Access Compliance Report

Public Rights-of-Way

Intersection ID: 14918	Main Street: KENILWORTH_AV	Cross Street: PIERCE_ST	Location: S
ADA ID: 45CD385DBD86	Ramp Type: Perp	Initial Pass/Fail: Fail	Overall Compliance: No
		Severity Score: 12.5

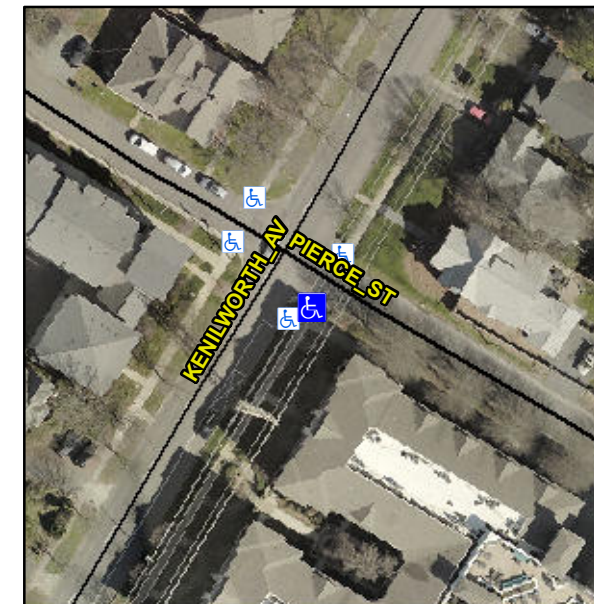
R304.2.2

Compliance	Description	Data	Compliance	Description	Data
N/A	Ramp Length (in)	120.0	No	Ramp Slope (%)	9.0
Yes	Ramp Width (in)	48.0	Yes	Ramp XSlope (%)	1.9
N/A	Flare Type LT	N/A	N/A	Flare Type RT	N/A
N/A	Flare Slope LT (%)	N/A	N/A	Flare Slope RT (%)	N/A
N/A	Flare Traversable LT?	N/A	N/A	Flare Traversable RT?	N/A
N/A	Landing Length (in)	N/A	N/A	DWS Provided?	N/A
N/A	Landing Width (in)	N/A	N/A	DWS Contrast?	N/A
N/A	Landing Slope (%)	N/A	N/A	DWS Length (in)	N/A
N/A	Landing X Slope (%)	N/A	N/A	DWS Full Width?	N/A
N/A	Landing Curb? (Y/N)	N/A	N/A	DWS Offset (in)	N/A
N/A	Shared Landing?	N/A			
N/A	Gutter Ponding?	N/A	N/A	Gutter Slope (%)	N/A
N/A	Gutter Lip Ht (in)	1.0	N/A	Gutter X Slope (%)	N/A
N/A	Painted X Walk1?	No	N/A	Painted X Walk2?	N/A
	X Walk 1 Direction	To NE		X Walk 2 Direction	N/A
N/A	X Walk 1 Width (in)	N/A	N/A	X Walk 2 Width (in)	N/A
	X Walk 1 Slope (%)	0.1		X Walk 2 Slope (%)	N/A
	X Walk 1 X Slope (%)	0.2		X Walk 2 X Slope (%)	N/A

Remove & Replace Entire Ramp.
